UNITED STATES
NUCLEAR REGULATORY COMMISSION
WASHINGTON, D. C. 20555

SUBJECT: INITIAL REVIEW AND RECOMMENDATIONS FOR SITE
SPECIFIC SPECTRA AT SEP SITES

Initial Review and Recommendations for Site Specific
Spectra at SEP Sites

Figure 10

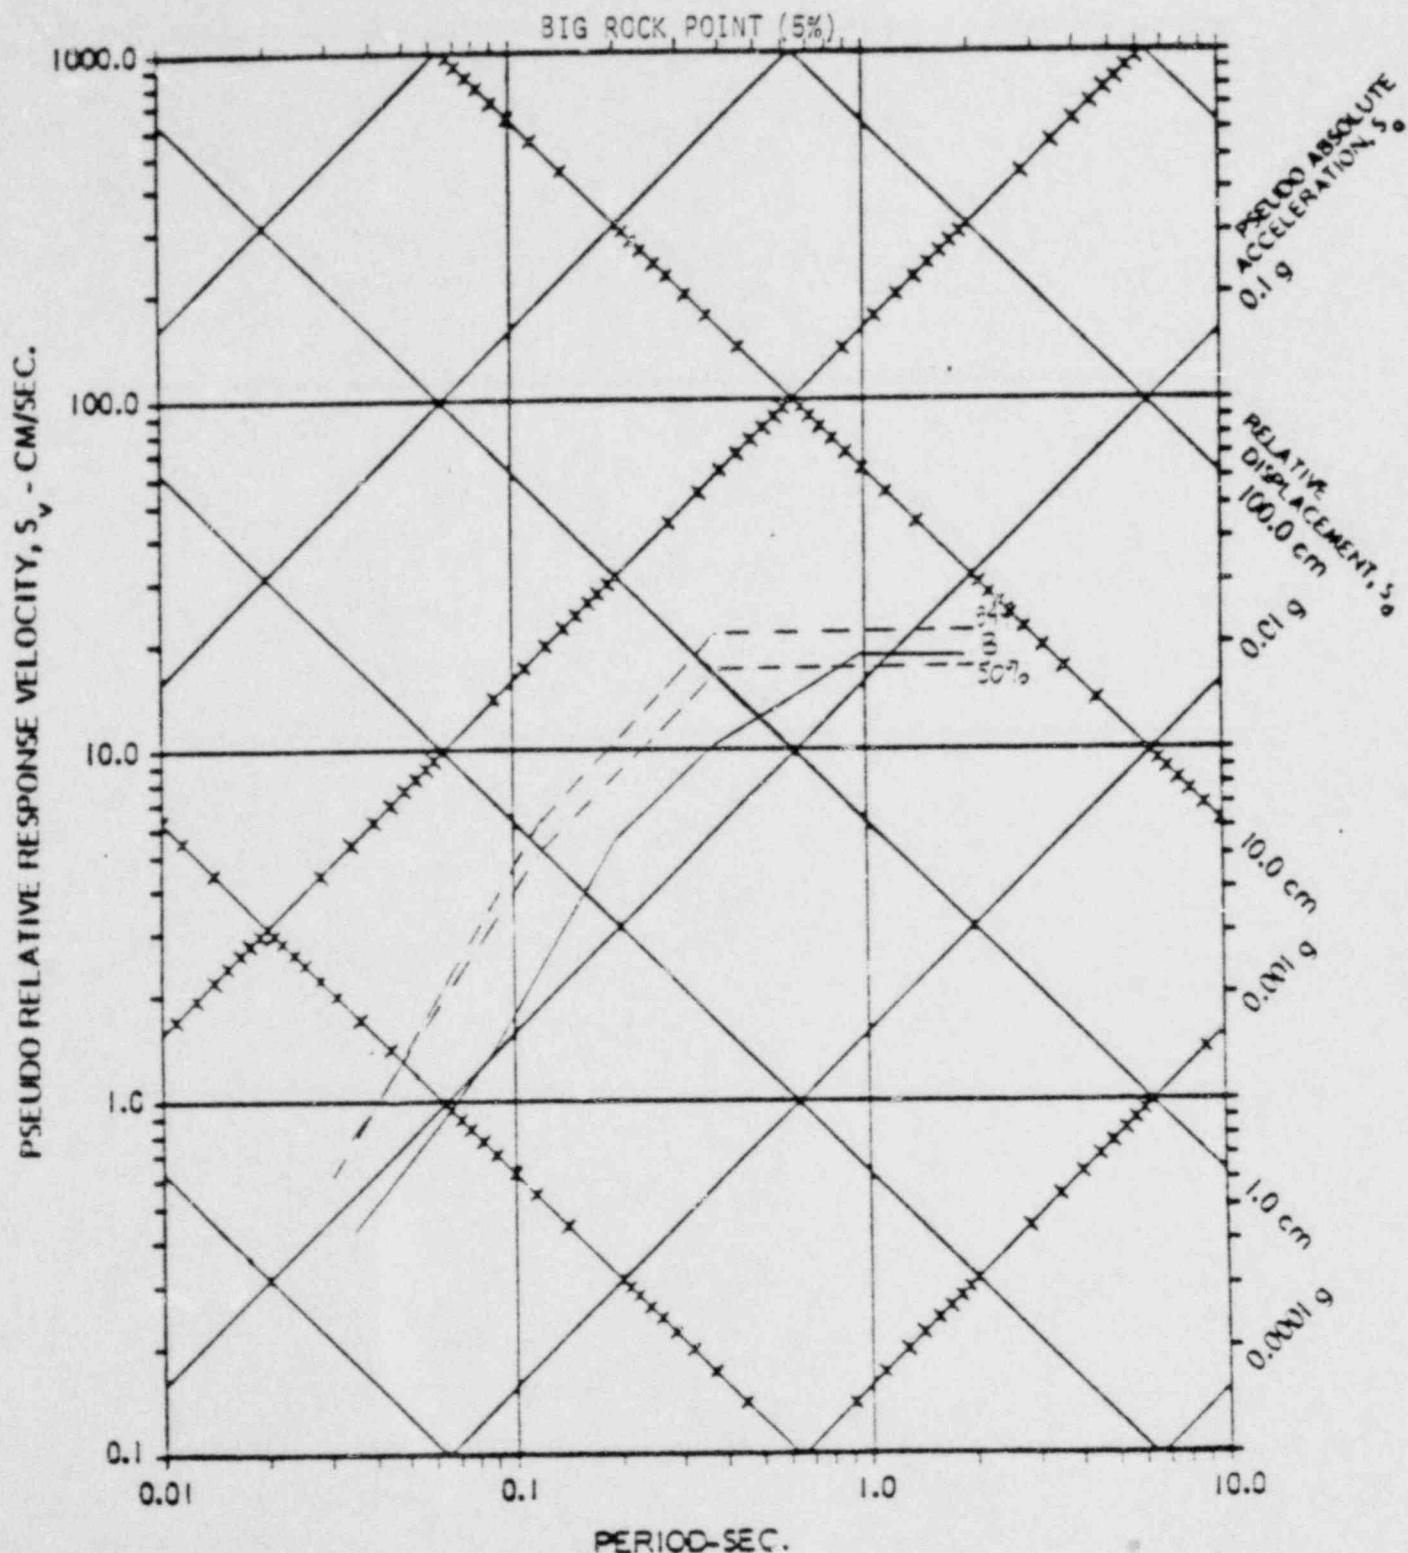
The deterministic peak accelerations and velocities are converted to response spectra using the amplification factors suggested by Newmark and Hall in NUREG CR-0098. Figs. 3 thru 11 compare the recommended uniform hazard spectra with 50th and 84th percentile deterministic spectra. In the central U.S. the recommended spectra generally fall below or at the 50th percentile. In the eastern United States the uniform hazard spectra are approximately

equivalent to the 84th percentile deterministic spectra. While the deterministic peaks are generally lower than the predicted peaks, use of the 84th percentile amplification factors usually more than compensate for the differences. Again the uniform hazard spectra more adequately reflect perceived relative hazard. The "tectonic province" approach can be made to achieve conservatism in this case by utilizing conservative amplification factors.

Figure 12

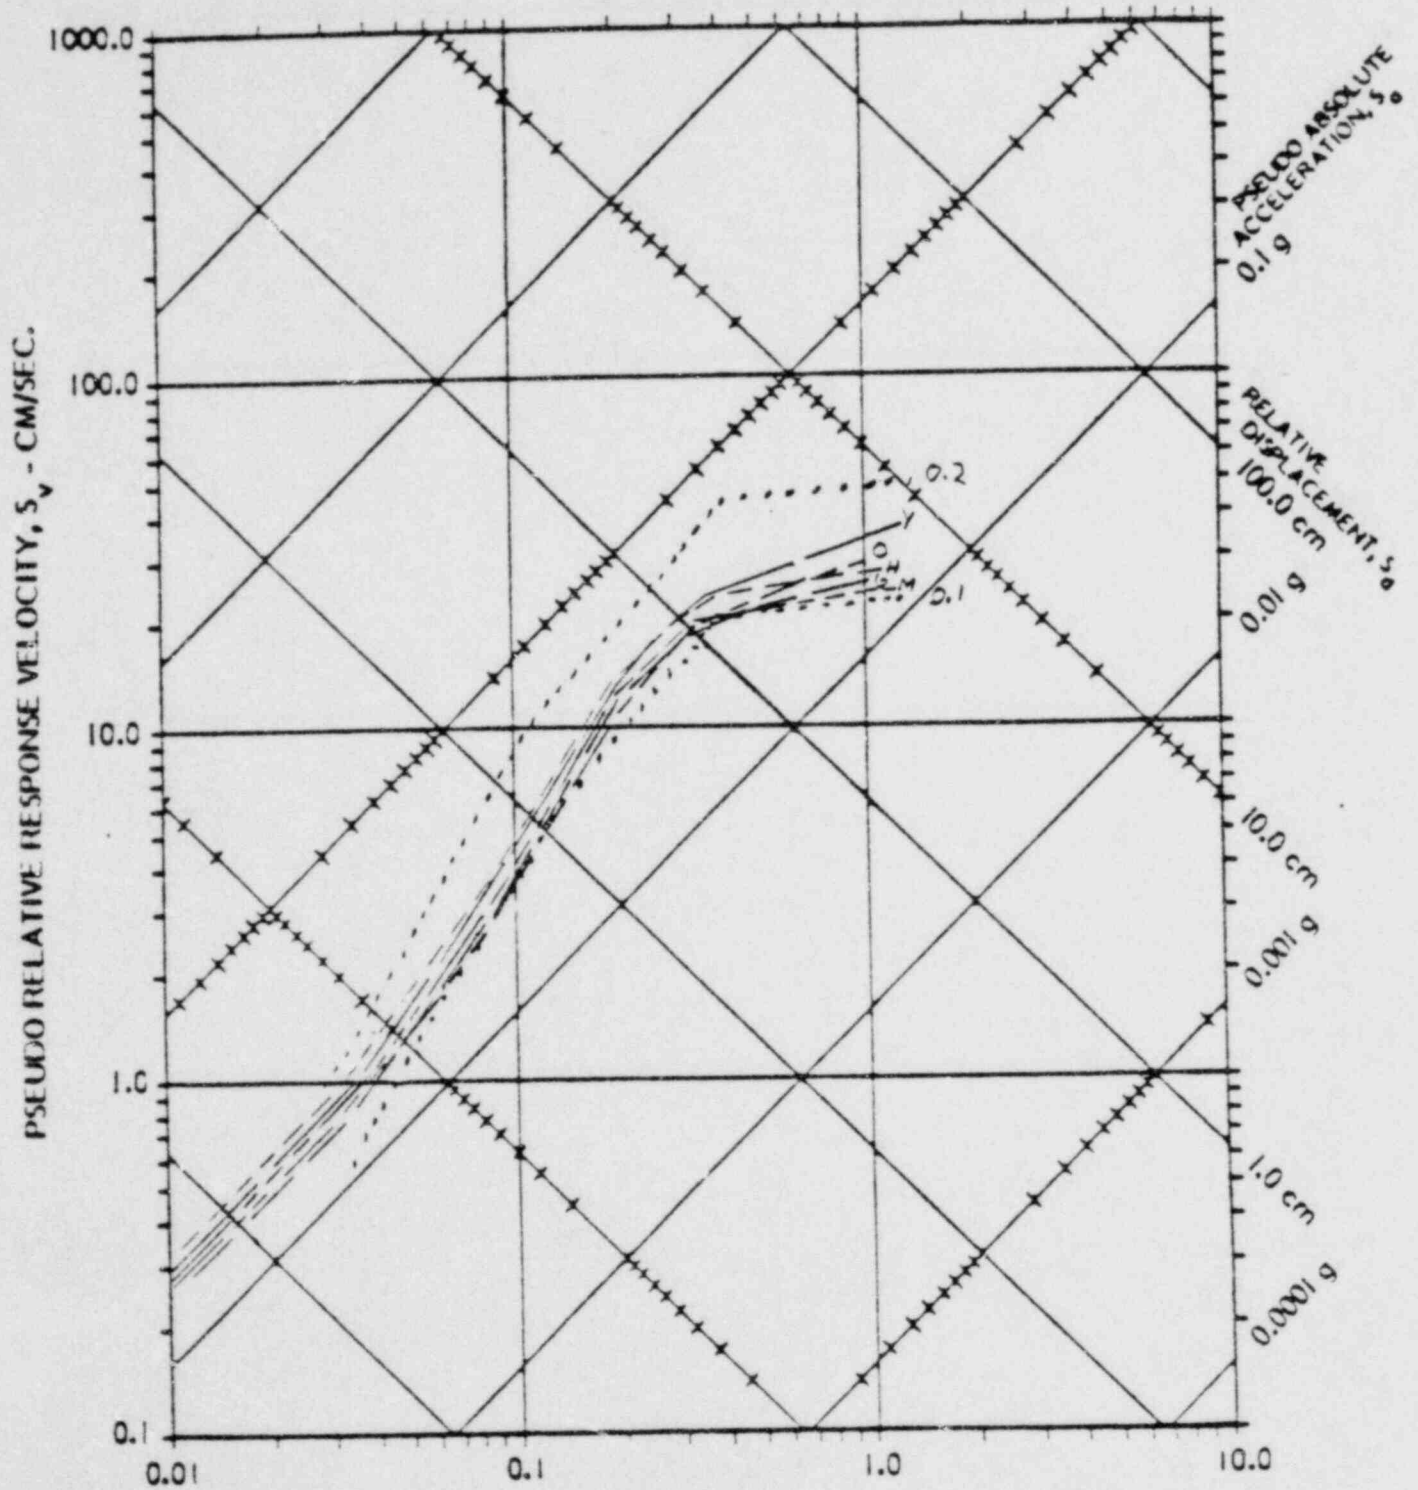
Figures 12 and 13 show the uniform spectra compared to Reg. Guide 1.60 spectra anchored at 0.1 and 0.2g. Following suggested Standard Review Plan procedures for new plants that is utilizing the trend of the means of Trifunac and Brady (1975) to anchor the Reg. Guide 1.60 spectra, would result in design spectra anchored at between 0.12 and 0.20g. The specific acceleration used would depend in large part upon the applicants submittal and the reviewer's conservatism. For the central U. S. the recommended spectra are mostly below the Reg. Guide spectrum anchored at 0.1g while for eastern U. S. the recommended spectra are at or above the Reg. Guide spectrum anchored at 0.1g. The average recommended spectrum would be roughly equivalent to the Reg. Guide 1.60 Spectrum anchored at a peak acceleration of about 0.1g. The observation that the average peak acceleration associated with the recommended spectra (Table 2) is about 0.15g illustrates the often discussed conservatism of the Reg. Guide spectrum. It was conservatively derived from earthquakes of different sizes recorded at different distances and different site conditions.

Figure 14

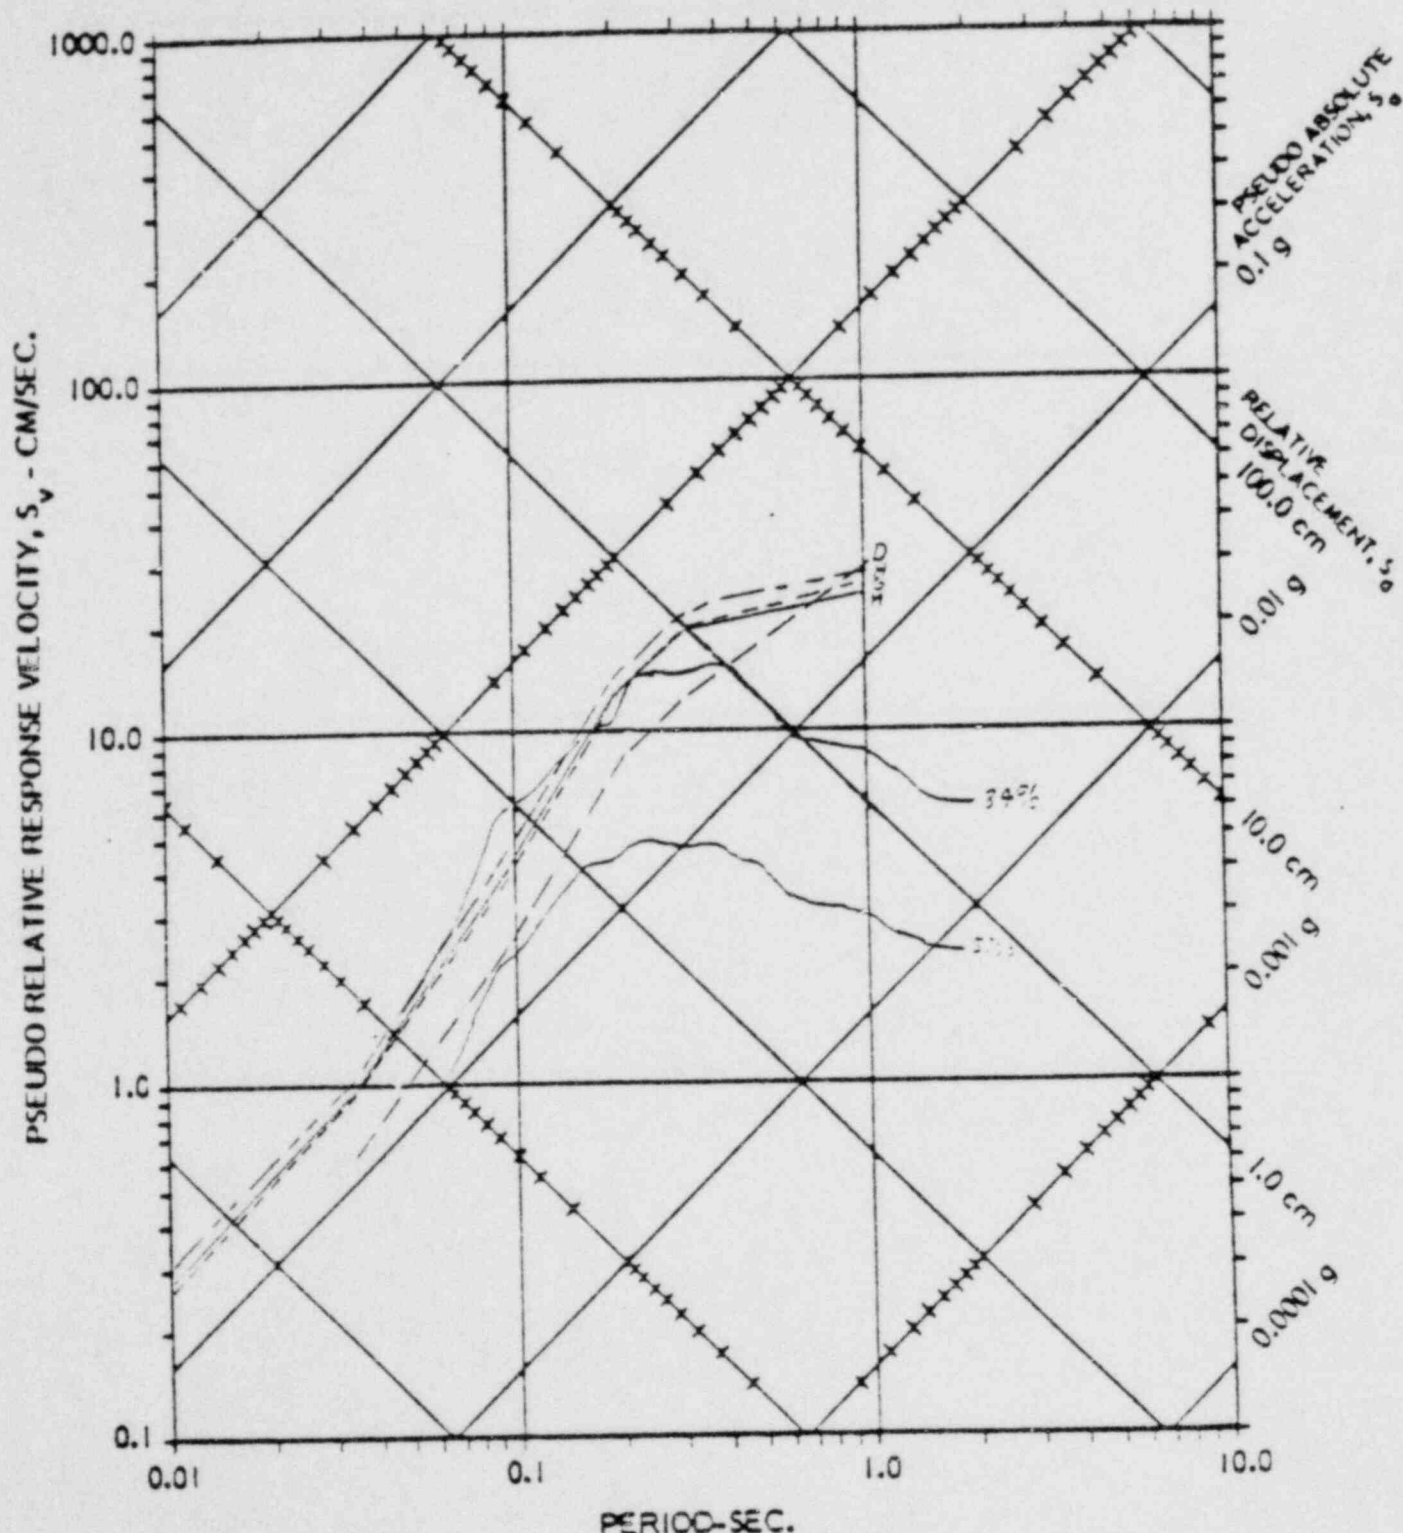
A more applicable comparison can be found in Figures 14 and 15. Here the recommended spectra are compared to the 50th and 84th Percentile levels of ensembles of response spectra derived from strong motion records recorded at nearby distances (usually 27 km or less) from earthquakes of magnitude

5.3 \pm 0.5 in the western U. S. and Italy. At these distances differences in regional attenuation are not pronounced. At periods less than 0.3-0.5 seconds the recommended spectra fall in between the 50th and 84th percentile except for Palisades, LaCrosse and Big Rock Point which are slightly below the 50th Percentile. Differences again can be related to real differences in earthquake hazard.

Figure 15

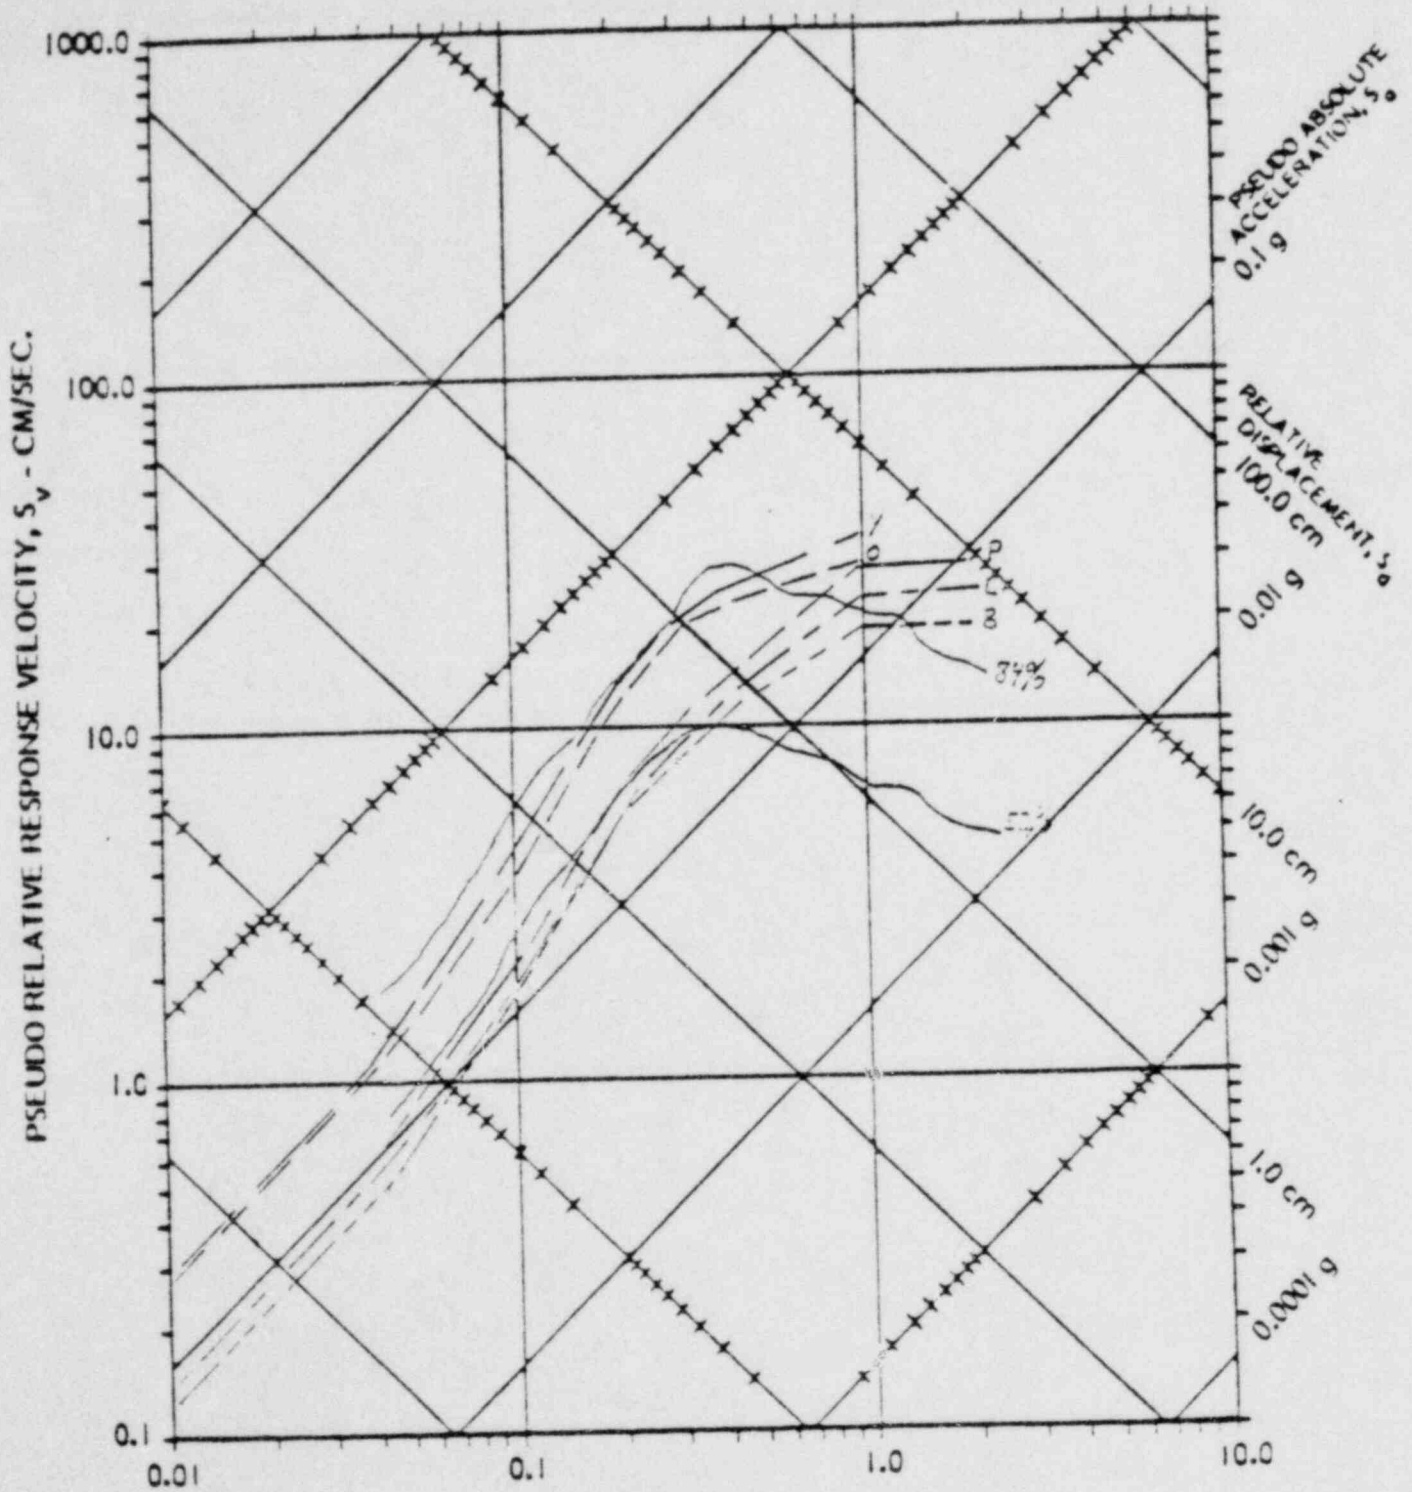
There can be some concern however in that the recommended spectra may fall below some minimum level of ground motion from a nearby magnitude 5.3 (Intensity VII). While Intensity VIII or larger earthquakes have been restricted in historical time in the central and eastern U.S. to five or six locations, Intensity VII earthquakes have occurred in sufficient numbers and at sufficient locations such that we believe that they could occur anywhere in the U.S. at varying levels of certainty. It is prudent therefore to establish such a minimum level although a direct uniform hazard assessment would more accurately reflect relative earthquake hazard. It is recommended that this minimum be set at the 50th percentile of the plotted real spectra. While the 84th percentile has been used in deterministic techniques it is not suggested that it be used as a minimum since it is more a reflection of the dispersion of data resulting from the magnitude and distance range needed to gather an adequate number of records for statistical treatment.

As indicated above use of the 50th Percentile would have a small effect upon LaCrosse, Palisades and Big Rock Point.
